# **87C196JT/87C196JT 20 MHz SPECIFICATION UPDATE**

Release Date: March, 1997

Order Number: 272859-003

The 87C196JT/87C196JT 20 MHz may contain design defects or errors known as errata. Characterized errata that may cause the 87C196JT/87C196JT 20 MHz's behavior to deviate from published specifications are documented in this specification update.

Figure 1. 16-bit System with EPROM

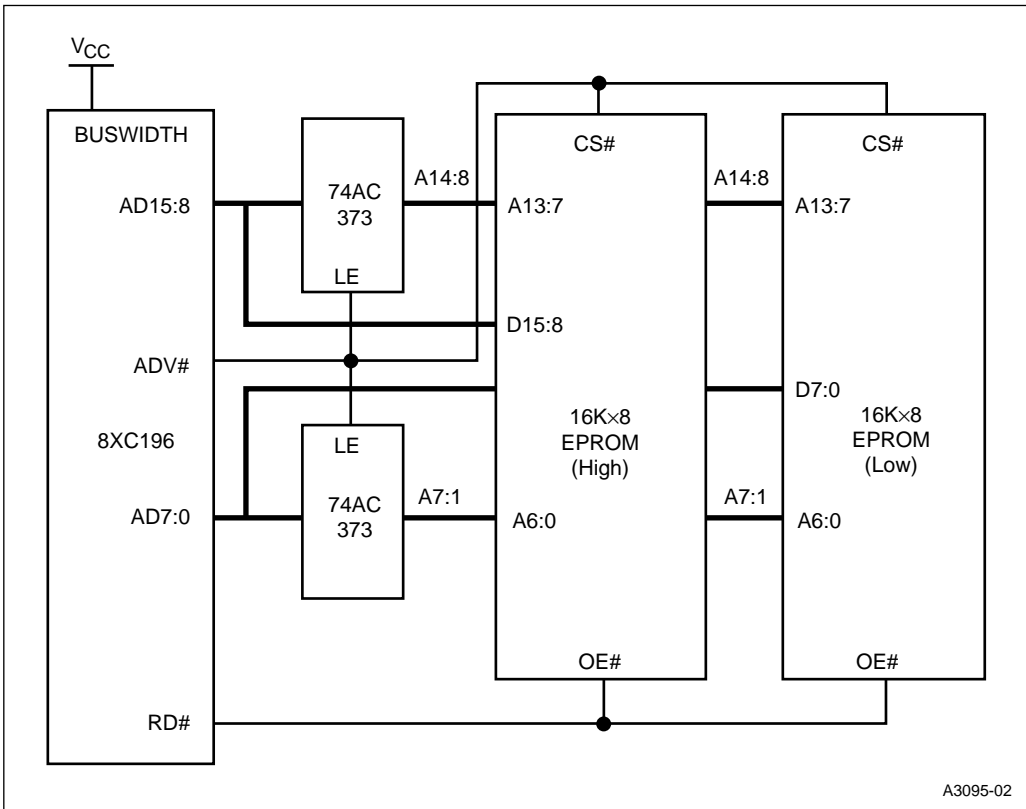
- 001.** *High address inputs to the low EPROM should be A14:8 in Figure 15-18.*

**ITEM:** The next revision of the user's manual will include the following corrected graphic.
